# HISTORIC AND DESIGN REVIEW COMMISSION

**HDRC CASE NO:** 2022-291  
**ADDRESS:** 801 N MAIN AVE  
**LEGAL DESCRIPTION:** NCB 787 BLK 7 LOT 15- 16 & S TRI 53.79 FT OF 10  
**ZONING:** D  
**CITY COUNCIL DIST.:** 1  
**APPLICANT:** Robert Flores/American GI Forum-National Veterans Outreach Program, Inc.  
**OWNER:** American GI Forum-National Veterans Outreach Program, Inc.  
**TYPE OF WORK:** New construction of a multi-family residence  
**APPLICATION RECEIVED:** May 06, 2022  
**60-DAY REVIEW:** Not applicable due to City Council Emergency Orders  
**CASE MANAGER:** Edward Hall  
**REQUEST:**

The applicant is requesting conceptual approval to construct a 4-story, residential structure at 801 N Main, located within the Downtown Design District.

American GI Forum  
Veterans Dormitory  
801 N. Main Street San Antonio, Texas. 78215

SHEET TITLE.  
SITE PLAN / ROOF  
PLAN

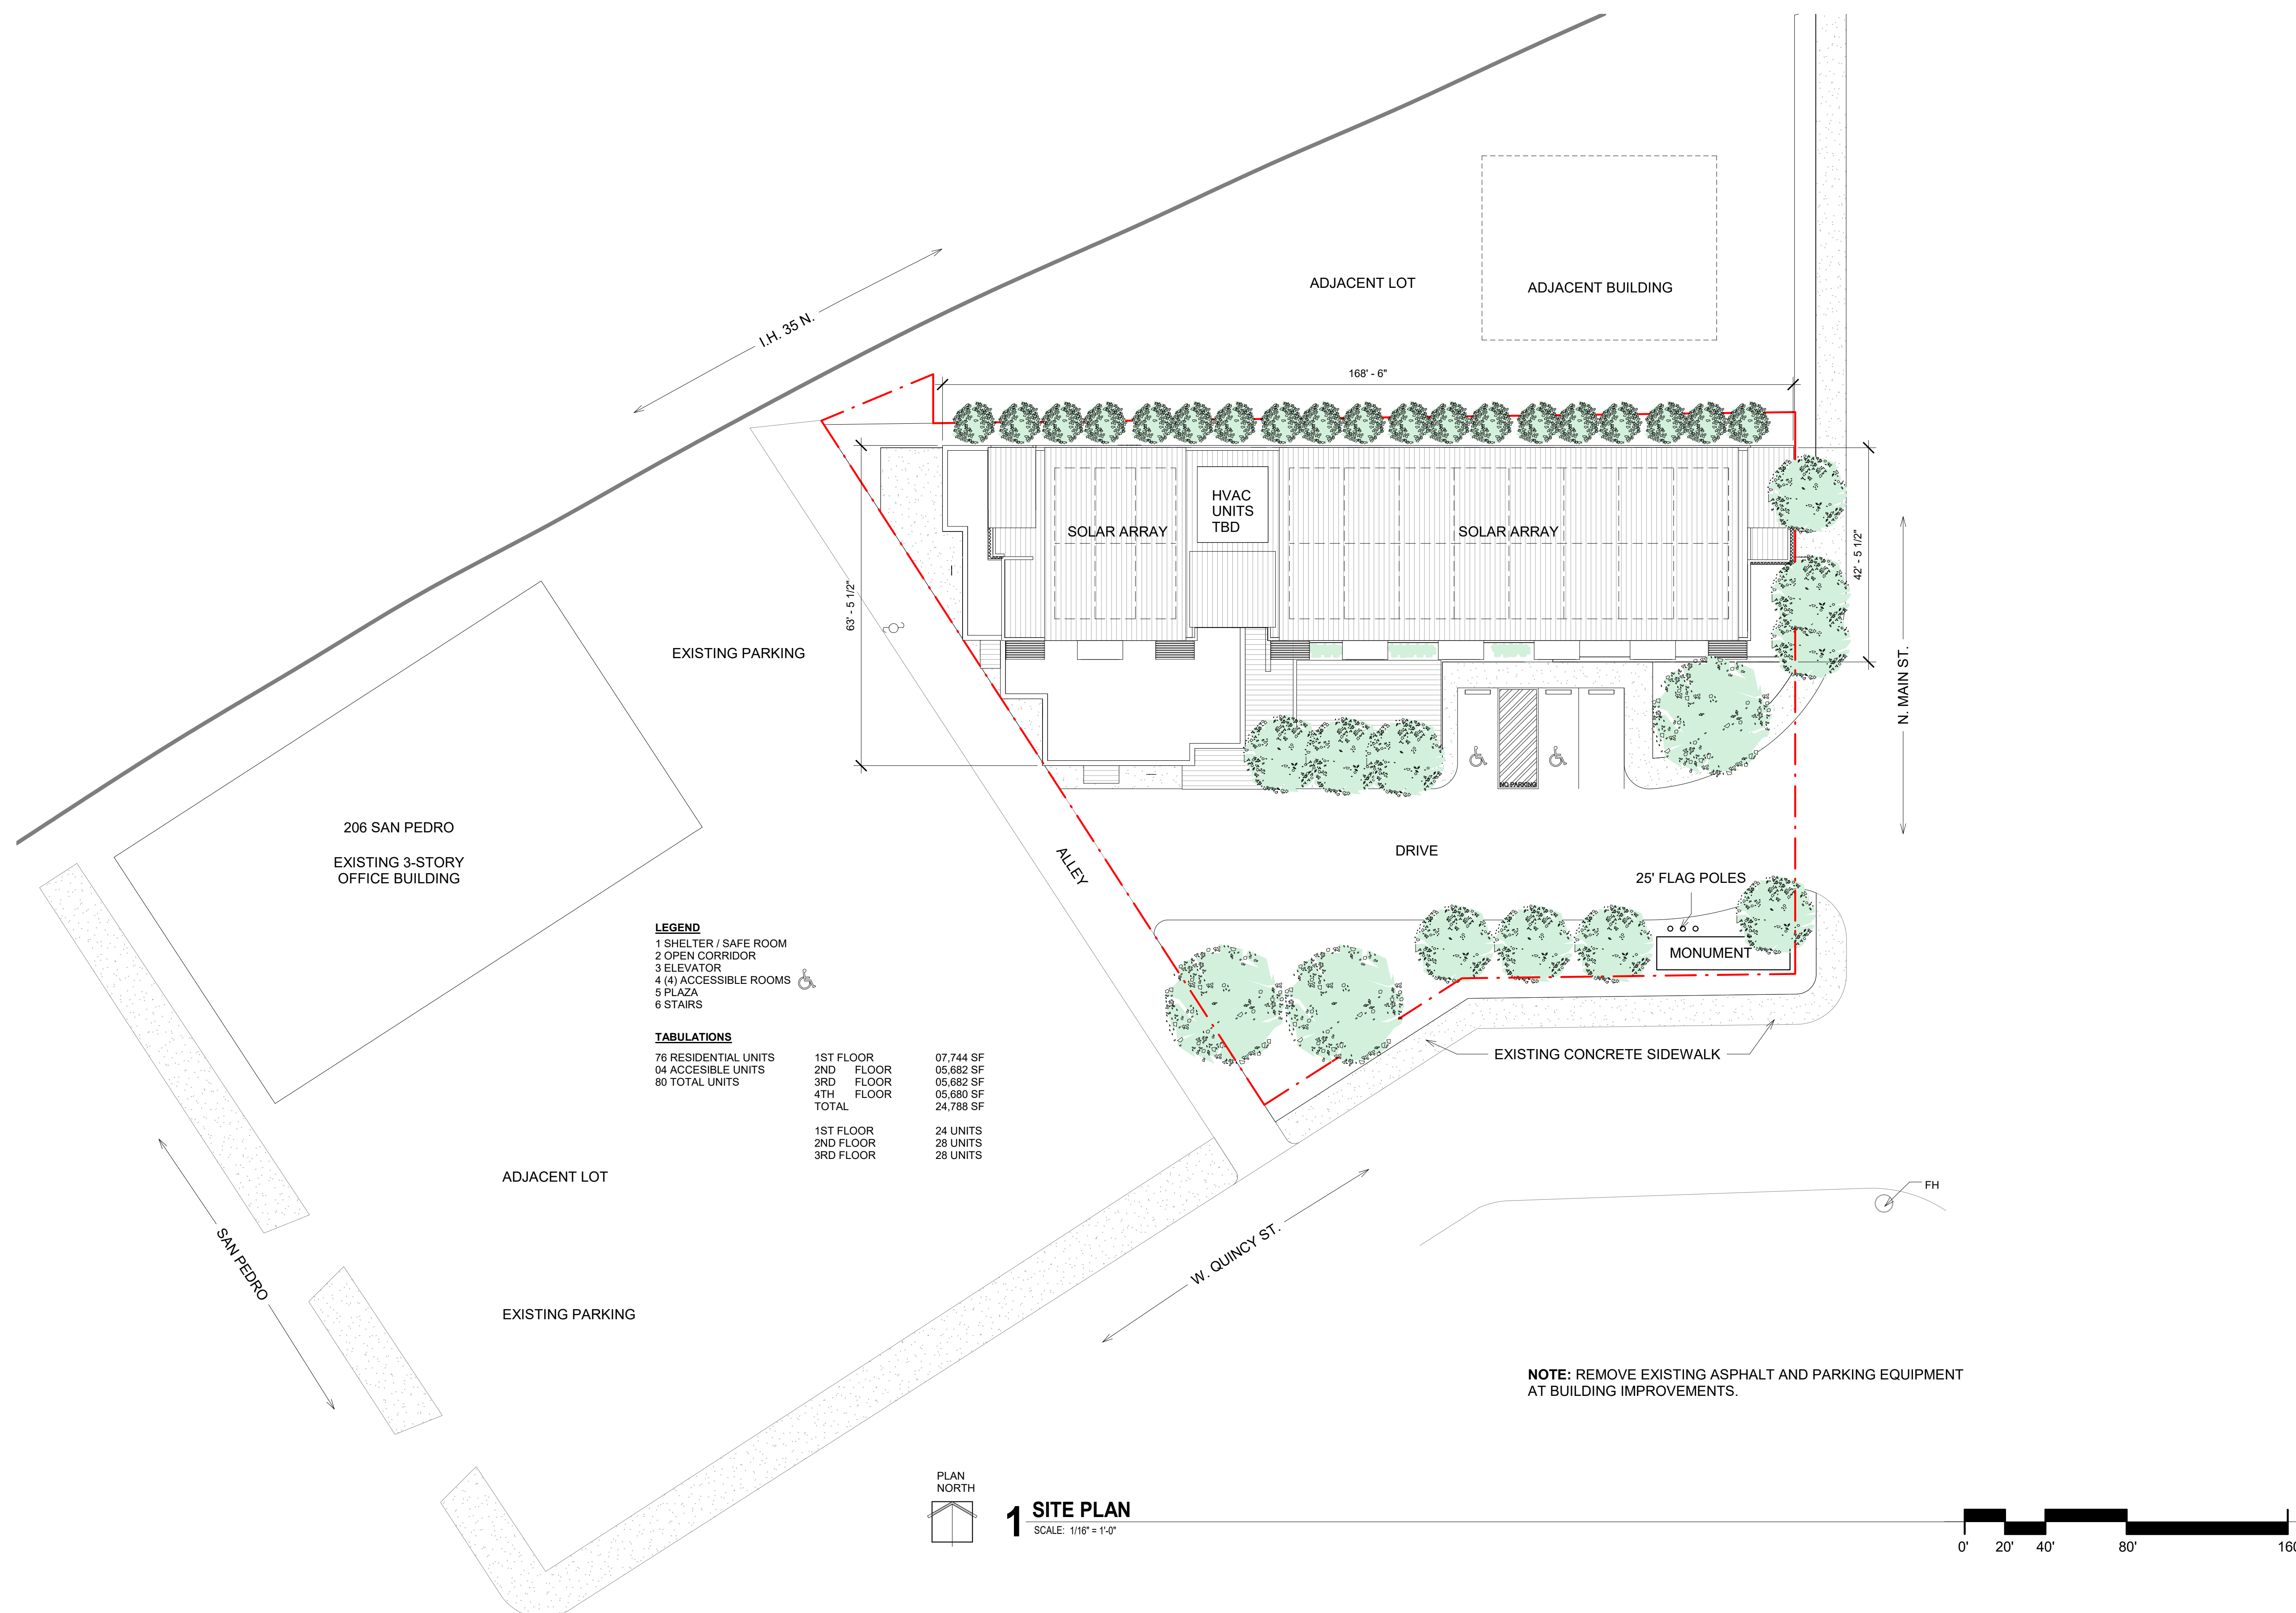
- d. SIDEWALK & SETBACK WIDTH – The applicant has proposed to maintain the existing sidewalks at the public right of way, as well as provide site paving within the site. Staff finds maintaining the existing sidewalks on site to be appropriate, as well as the installation of interior sidewalks.

- e. **LANDSCAPE & HARDSCAPE** – The applicant has submitted a site plan that notes the installation of various street trees and hardscaping areas. Staff finds the proposed landscaping and hardscaping plans to be appropriate and consistent with the Downtown Design Guide.

- f. **ON-SITE OPEN SPACE** – The applicant has noted on site open space via a courtyard that is located to the south of the proposed new construction. Staff finds this to be appropriate and consistent with the Downtown Design Guide.

SHEET TITLE:  
EXTERIOR  
ELEVATIONS

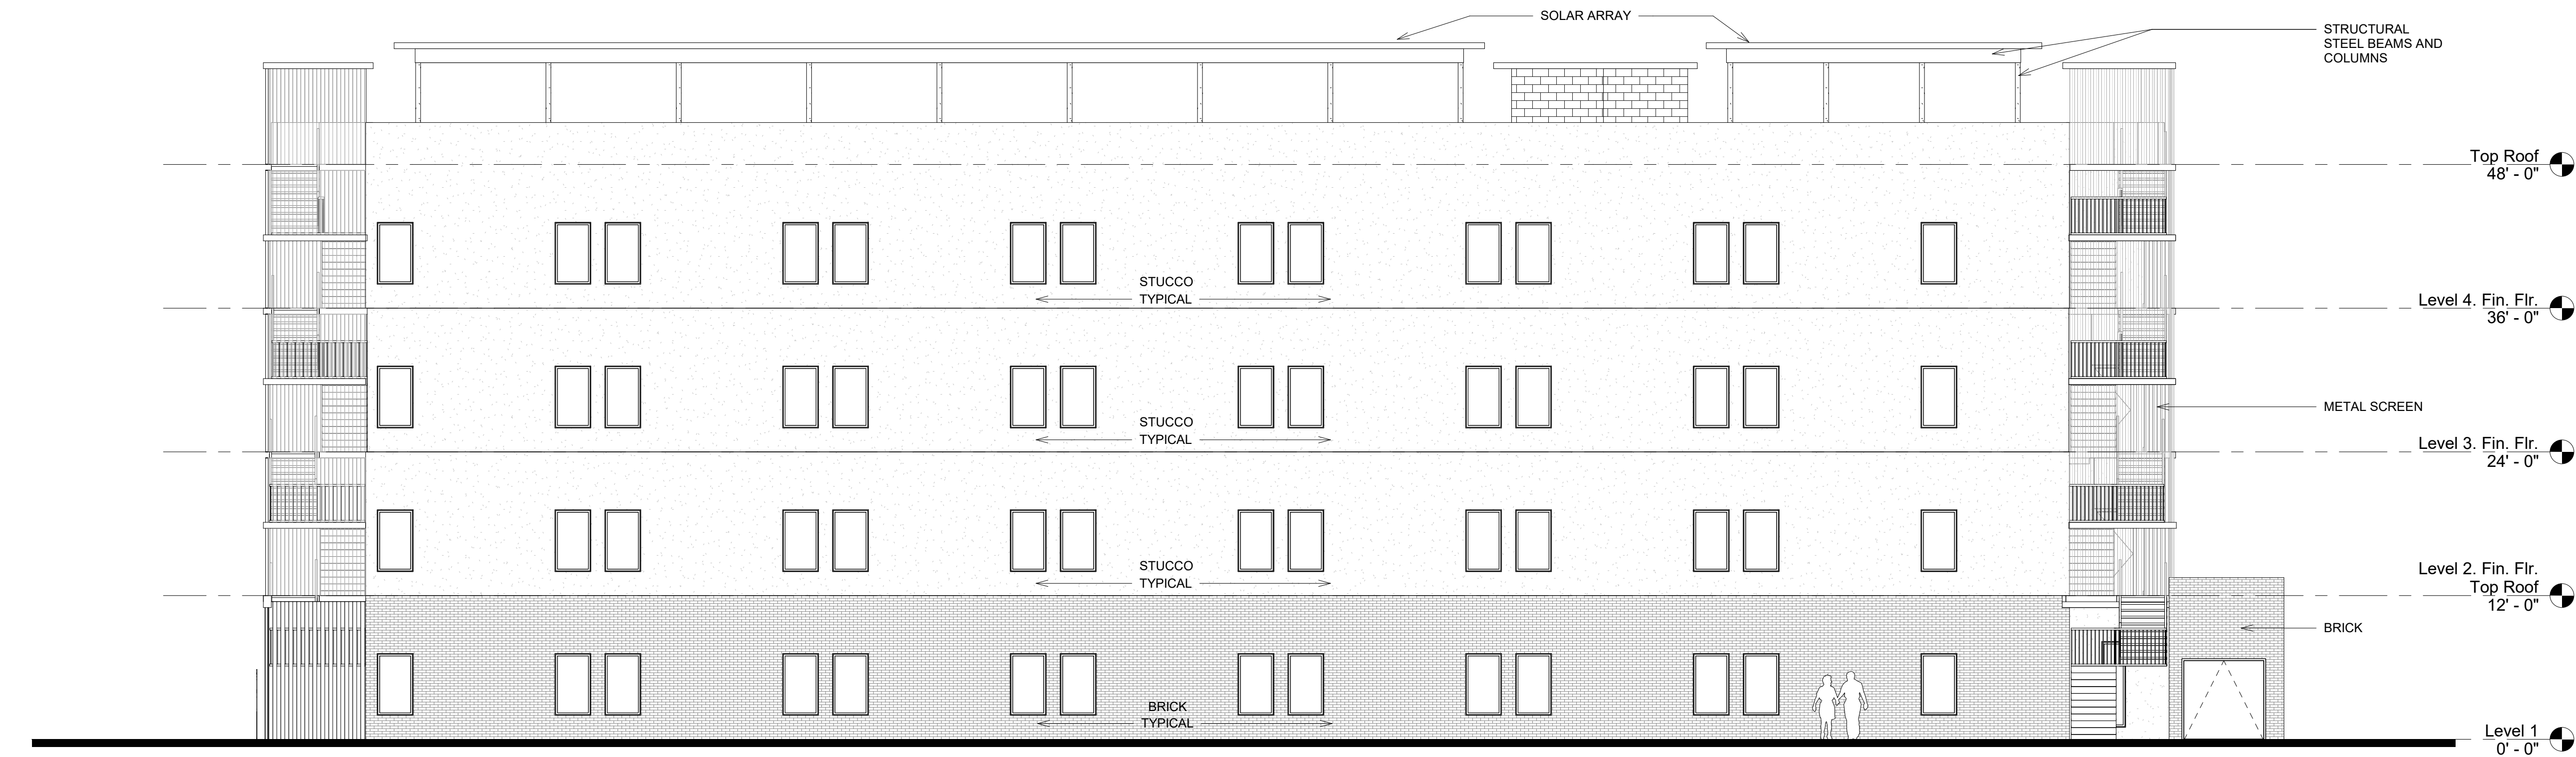
- g. **GROUND FLOOR TREATMENT** – Chapter 3, Section A of the Downtown Design Guide notes that active uses are to be located along the street façade, that ground floor retail space shall feature a depth of at least twenty-five (25) feet in depth and an overall floor to ceiling height of fourteen (14) feet. Additionally, storefront systems, windows and doors shall comprise of seventy (70) percent of the street façade. At this time the applicant has proposed a ground floor that is to feature approximately 12' – 0" in height. Staff finds that to meet the intent of the Downtown Design Guide, the applicant should explore ways to increase the ground floor height to 14' – 0" or install brick at the base to feature approximately 14' – 0" in height. Additionally, staff finds that the applicant should explore an increase in fenestration at the ground level and incorporate an entrance orienting element, such as an awning on the east façade.

- i. **MASSING & STREET WALL** – The applicant has proposed for the structure to feature four (4) stories in height. The Downtown Design Guide 5.A.i. notes that large building facades should be divided so that no building section is longer than 100 feet in length. Additionally, structures should feature a base, middle and cap, should maintain the alignment of other horizontal elements on the block and should feature floor to floor heights similar to other structures on the block. Generally, staff finds the overall massing to be appropriate; however, staff finds that the applicant should introduce architectural elements to the north façade to break up the facade and that the applicant should introduce architectural elements, such as a cornice to create a building cap. A change in materials or material profile and color should be explored to meet these requirements.

- j. **MATERIALS** – The applicant has noted brick at the street level, stucco facades for levels two through four, metal screens, and a CMU elevator core. CMU is prohibited by the Downtown Design Guide. Staff finds that CMU that is covered in stucco would be appropriate. CMU that features an architectural appearance may also be appropriate; however, the exact detail is to be submitted to OHP staff for review and approval.

- k. **WINDOWS** – The applicant has not specified window materials at this time; however, the applicant has noted the installation of picture windows. The Downtown Design Guide notes that windows should add depth to a building's façade and should be well detailed where they meet façade materials to provide adequate weather protection and to create a shadow line. Staff finds that that windows should feature dark colored frames, no faux divided lites or faux internal grilles and be installed to feature a depth of at least two (2) inches.

- i. That the applicant increase the ground floor height to 14' – 0" or install brick at the base to feature approximately 14' – 0" in height to meet the intent of the Downtown Design Guide, as noted in finding g.
- ii. That the applicant increase fenestration at the ground level and incorporate an entrance orienting element, such as an awning, on the east, street facing façade, as noted in finding g.

- iii. That the applicant introduce architectural elements to the north façade to break up the façade and that the applicant introduce architectural elements, such as a cornice to create a building cap, as noted in finding i. A change in materials or material profile and color should be explored to meet these requirements.
- iv. That the proposed CMU elevator tower be covered in stucco, or be given an architectural appearance that is simply not an unfinished stucco elevator core, as noted in finding j.
- v. That windows feature dark frames, no faux divided lites or faux internal grilles and be installed to feature a depth of at least two (2) inches.
- vi. That all mechanical equipment be screened from view from the right of way.
- vii. ARCHAEOLOGY – The project shall comply with all federal, state, and local laws, rules, and regulations regarding archaeology, as applicable.
